Meeting Date: September 10, 2024

Planning and Zoning Board Meeting

B) SITE PLAN – PATEL FUEL & RETAIL: A REQUEST BY WALKER OWEN, P.E., OF CAUSSEAUX, HEWETT, & WALPOLE, LLC, APPLICANT, ON BEHALF OF SEMOJ 13, LLC, PROPERTY OWNER, FOR CONSIDERATION OF A SITE PLAN TO CONSTRUCT A ±8,836 SQUARE FOOT CONVENIENCE STORE, RETAIL BUILDING, AND GASOLINE FUELING STATION WITH ASSOCIATED SITE IMPROVEMENTS (QUASI-JUDICIAL HEARING).

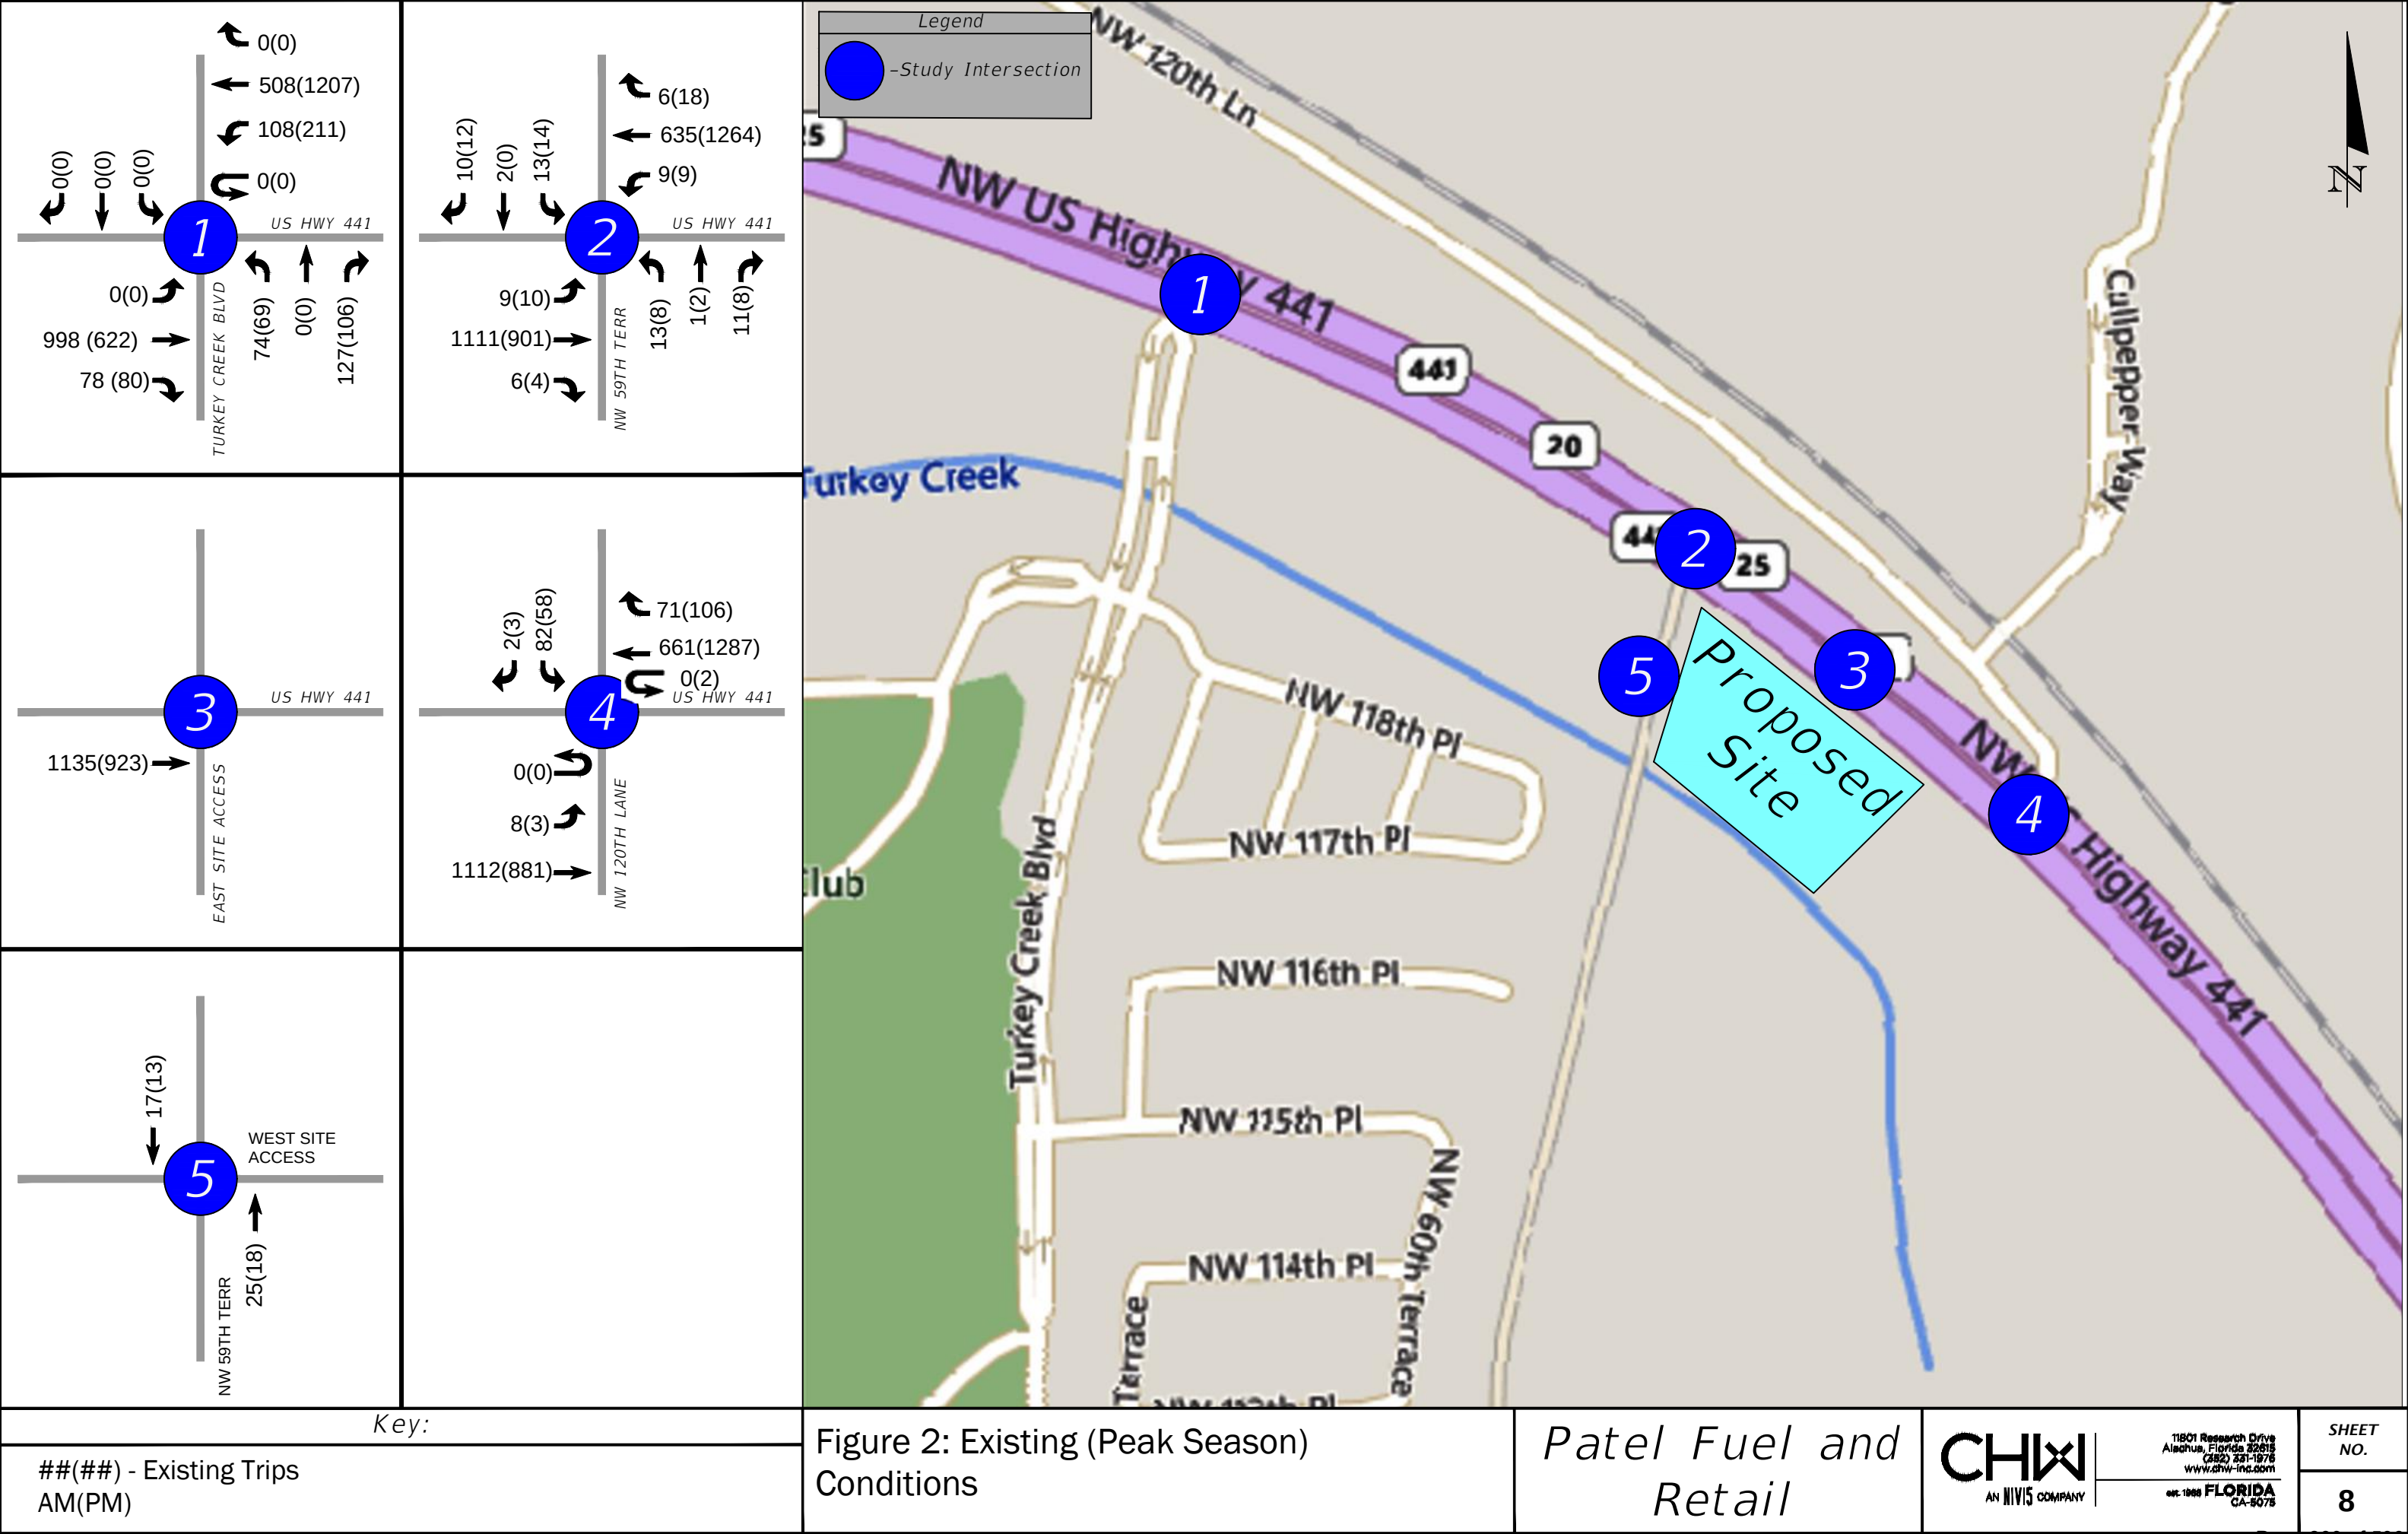
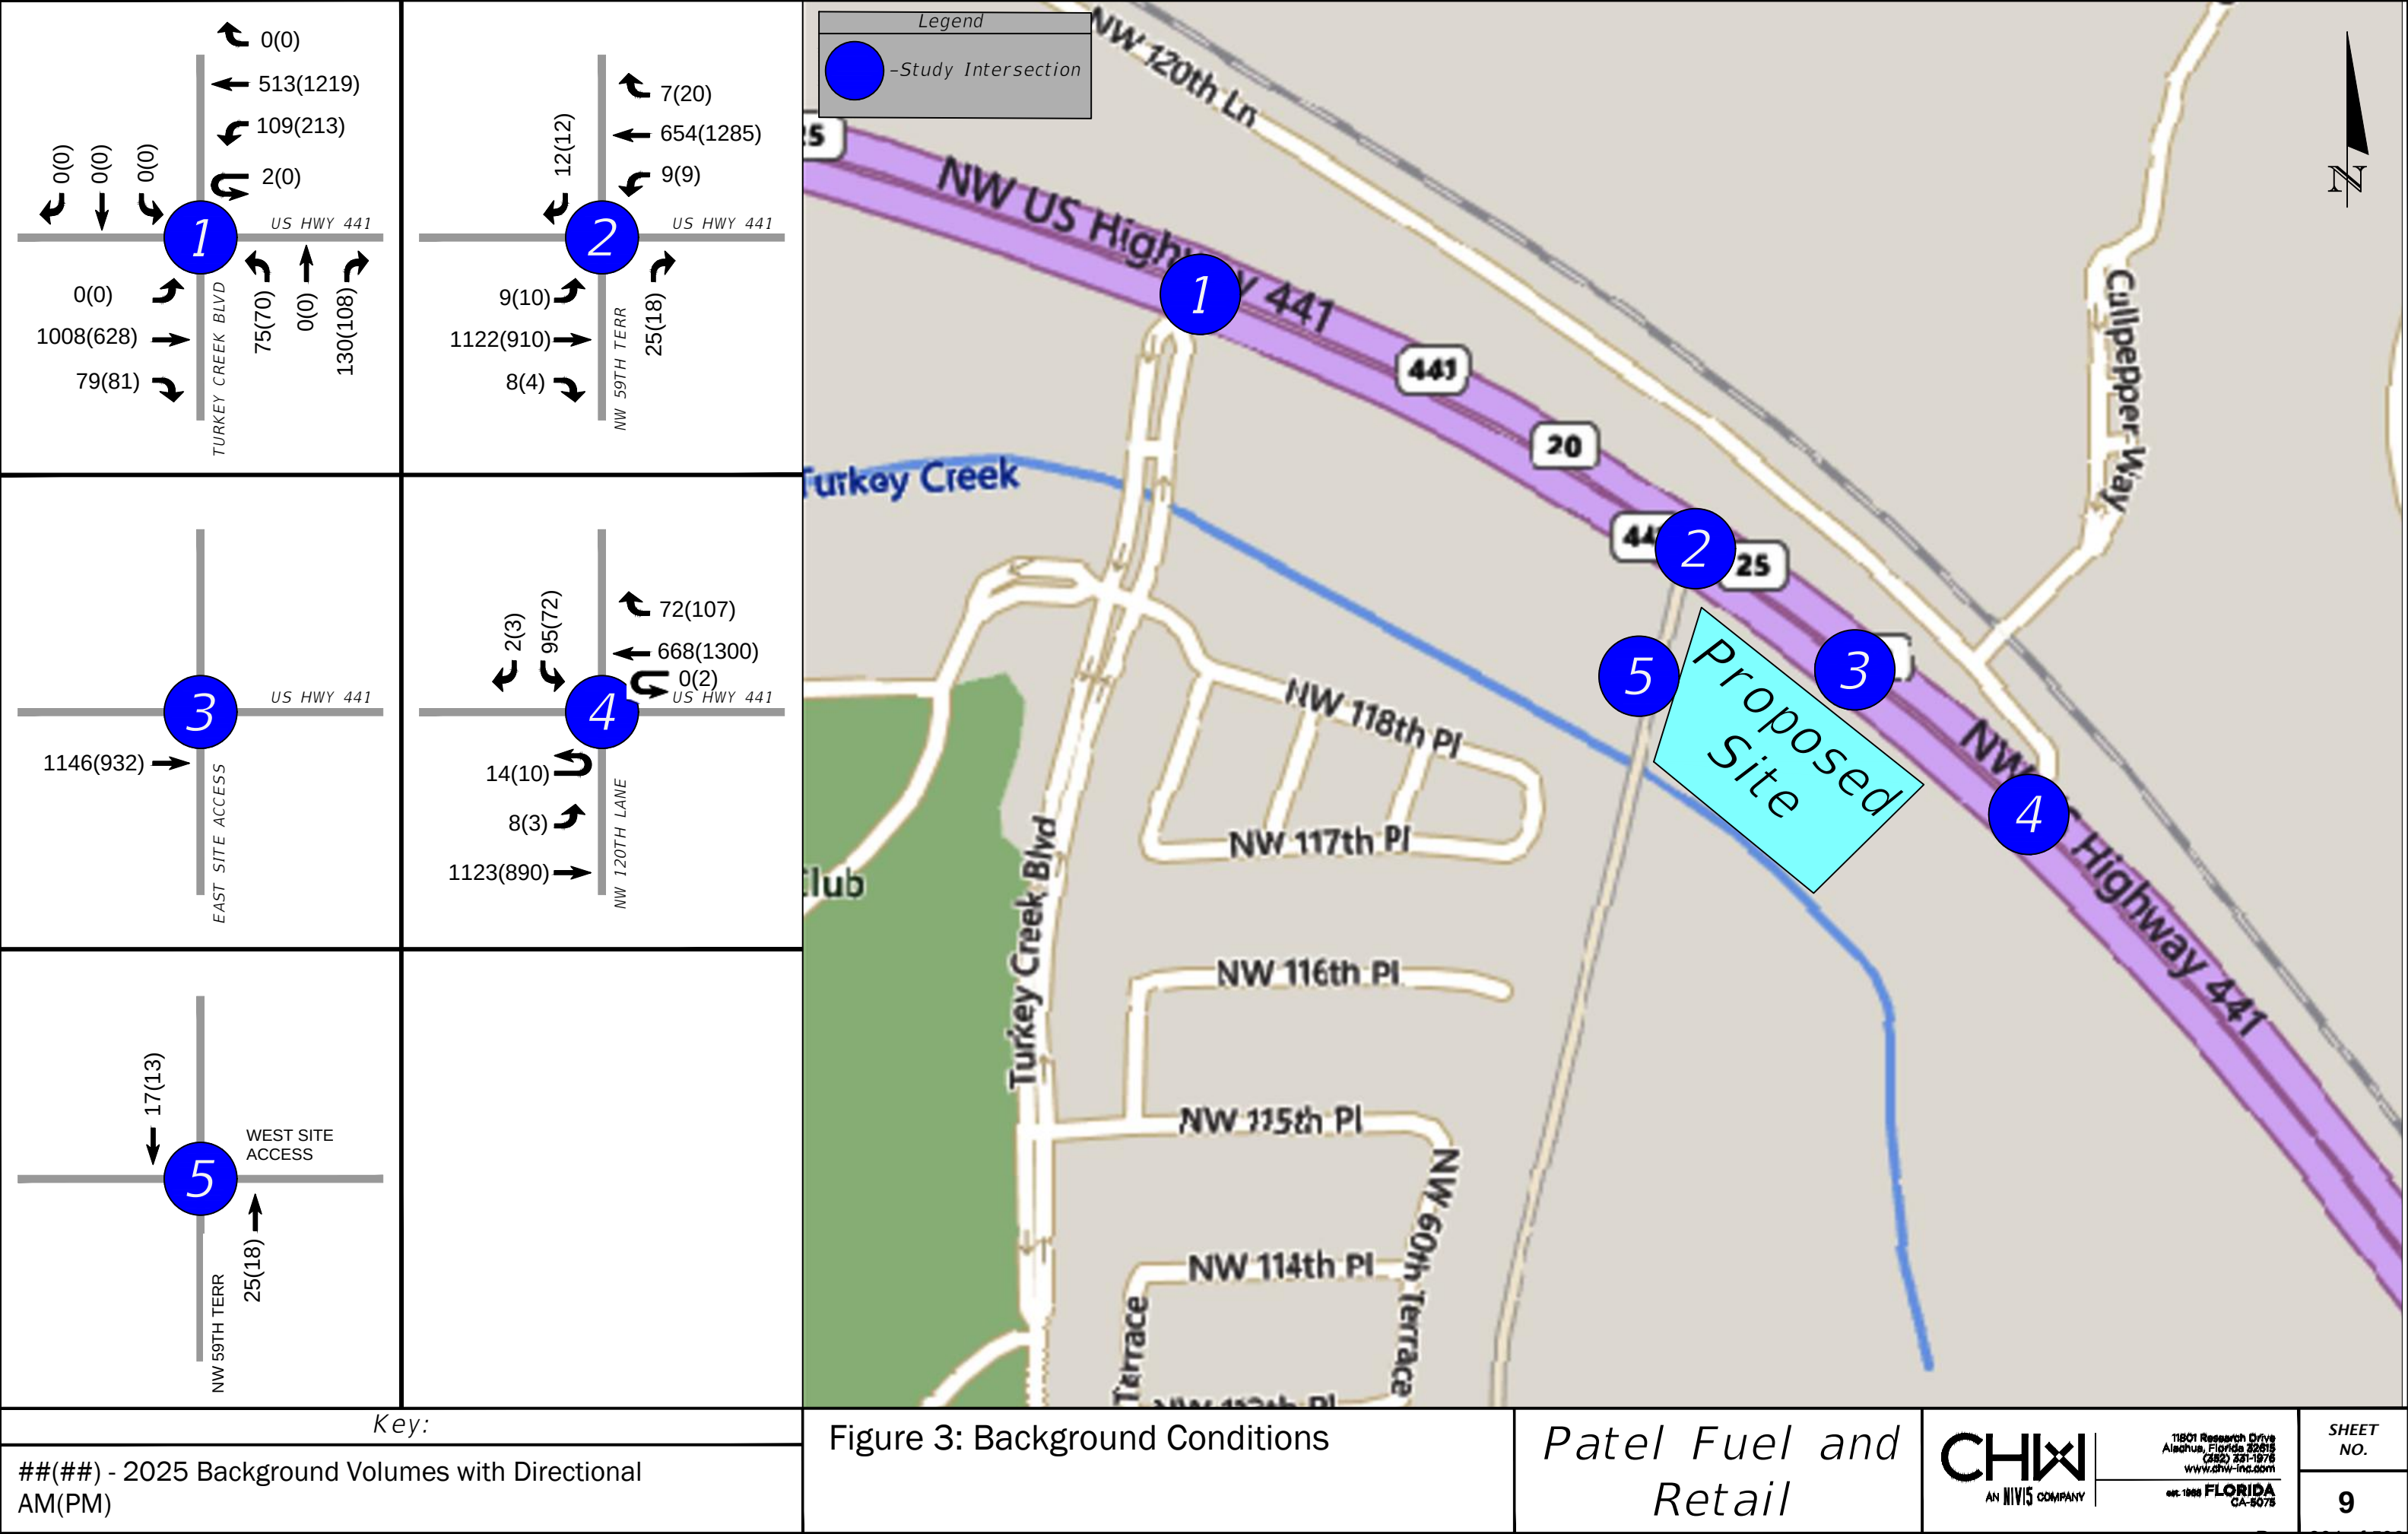
1. In Figure 2, Existing (Peak Season) Conditions and Figure 3, Background Conditions, intersection #5 has an incorrect street name. The north/south street should be labeled NW 59th Terrace, not NW 25th Terrace.

1. In Figure 2, Existing (Peak Season) Conditions and Figure 3, Background Conditions, intersection #5 has an incorrect street name. The north/south street should be labeled NW 59th Terrace, not NW 25th Terrace.
Response: The street name in Figure 2 and Figure 3 has been corrected as requested.

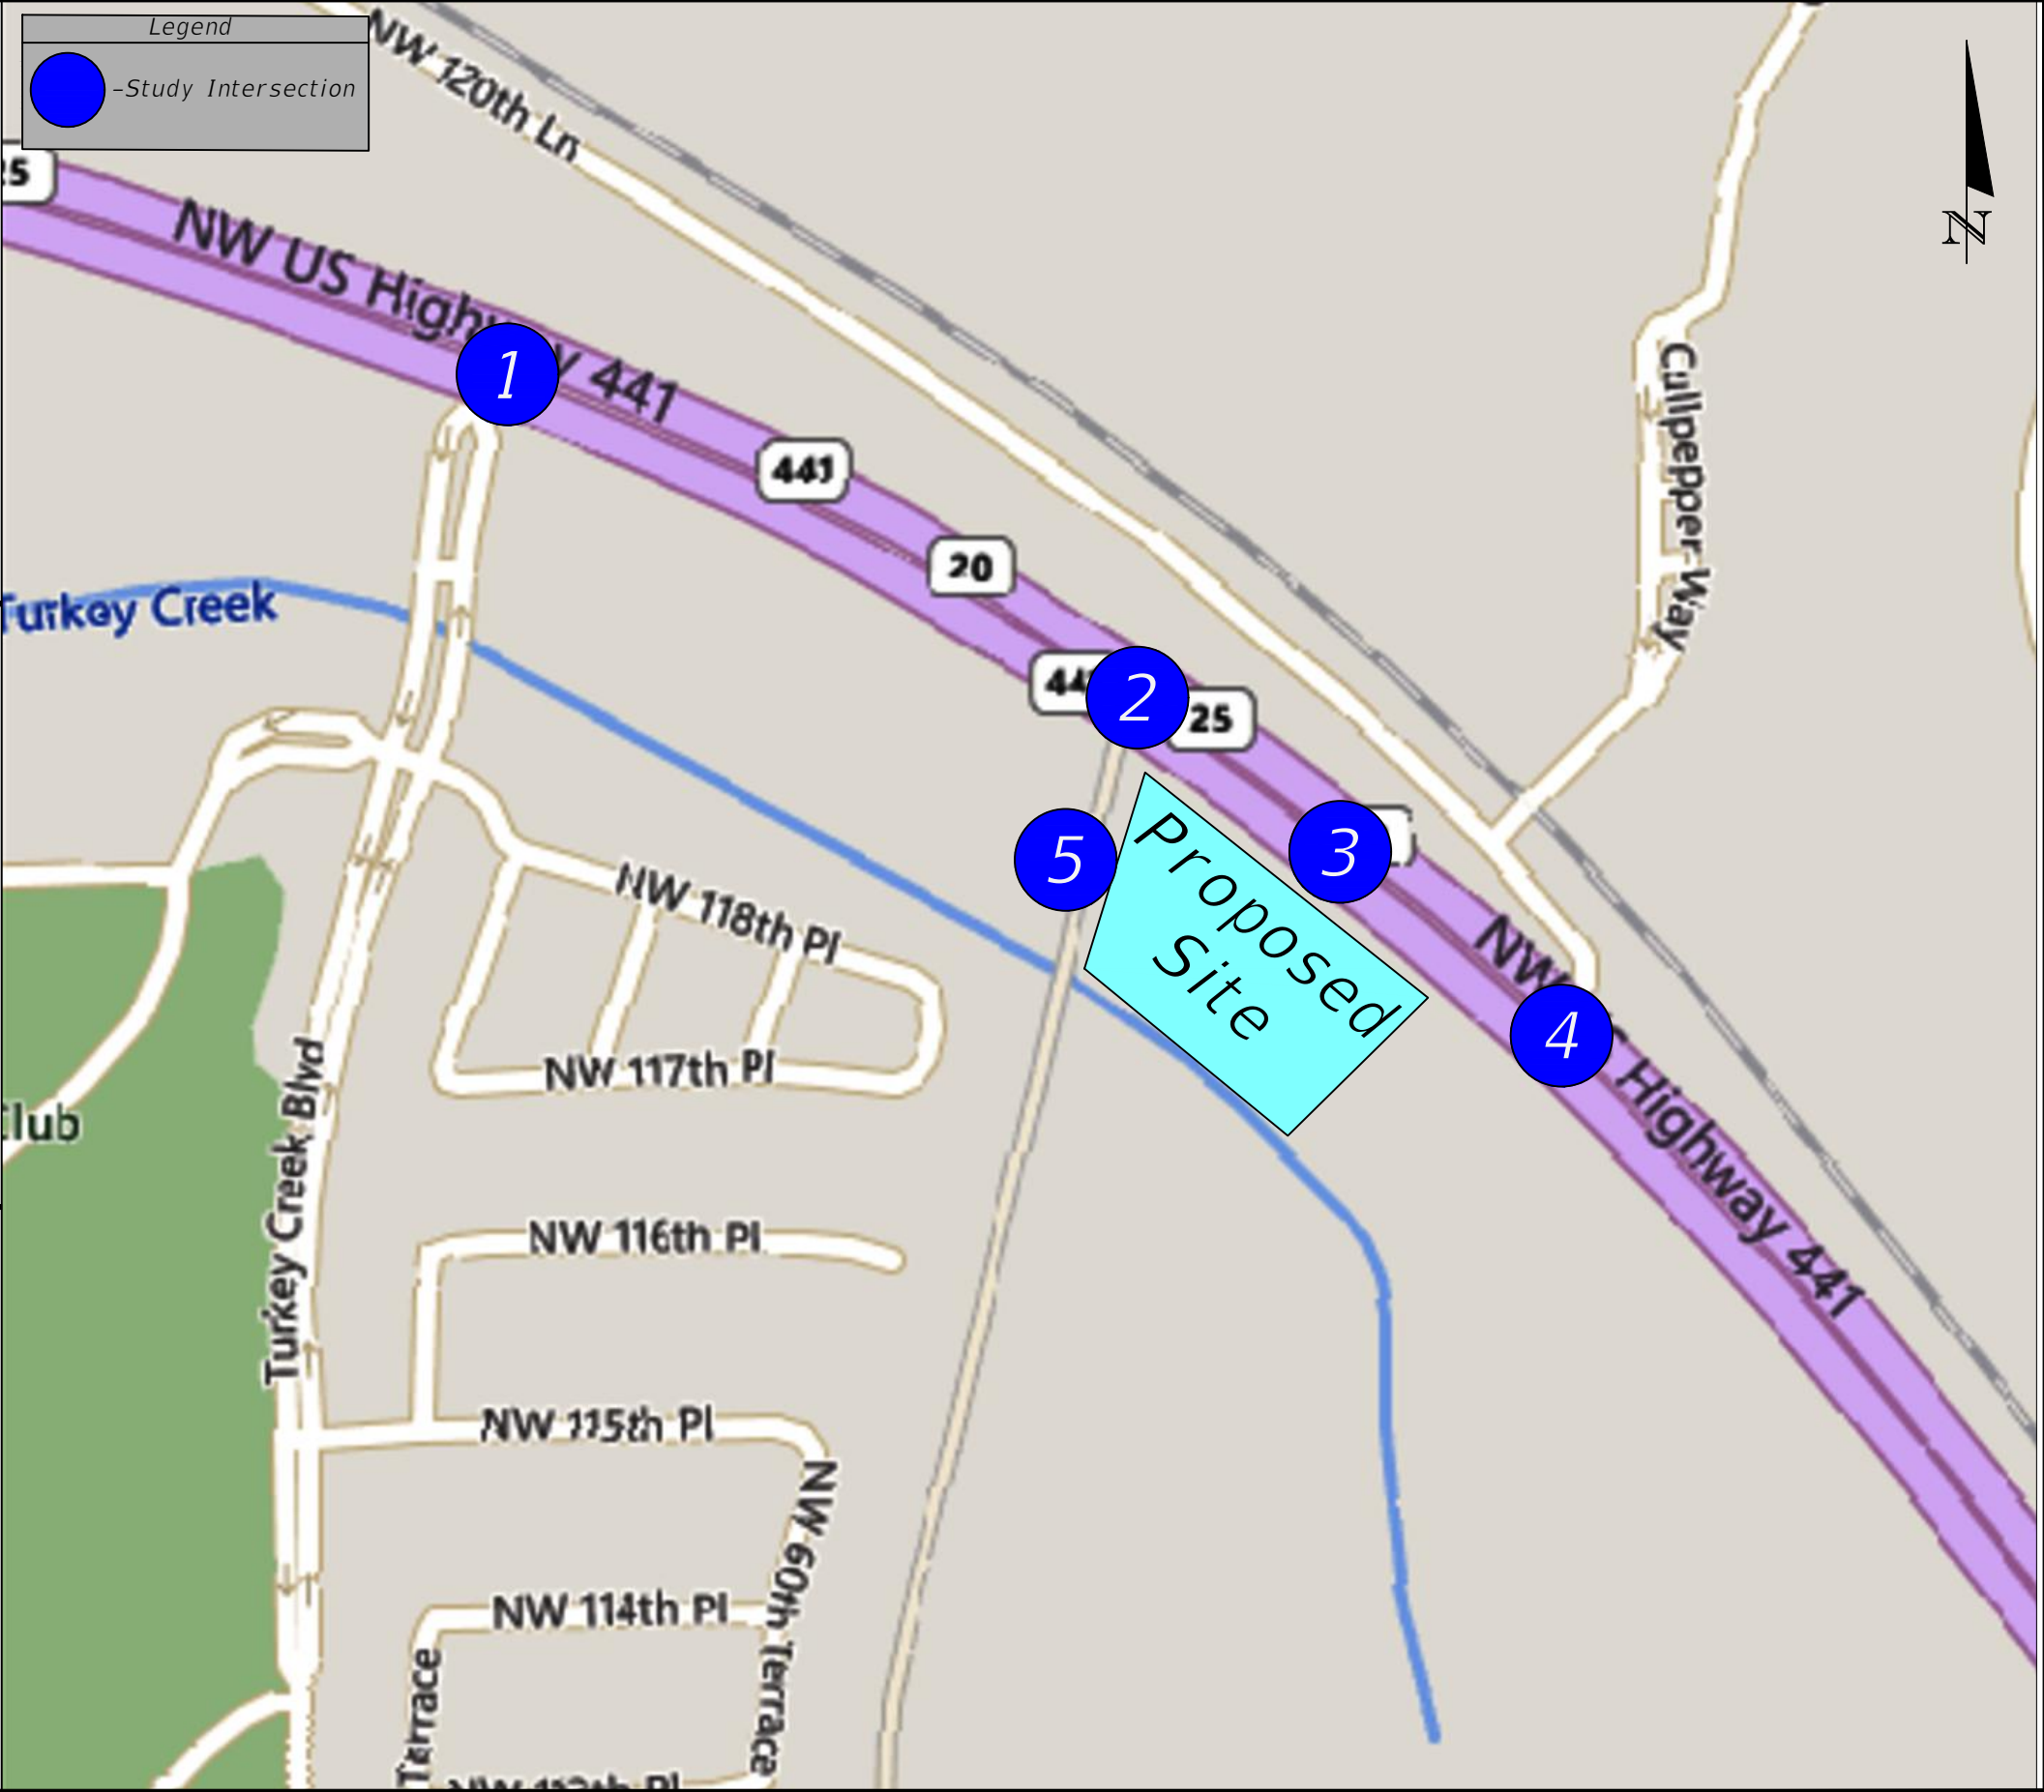
1. In Figure 4, Buildout Condition, intersection #5 has an incorrect street name. The north/south street should be labeled NW 59th Terrace, not NW 25th Terrace.

1. In Figure 4, Buildout Condition, intersection #5 has an incorrect street name. The north/south street should be labeled NW 59th Terrace, not NW 25th Terrace.
Response: The street name in Figure 4 has been corrected as requested.
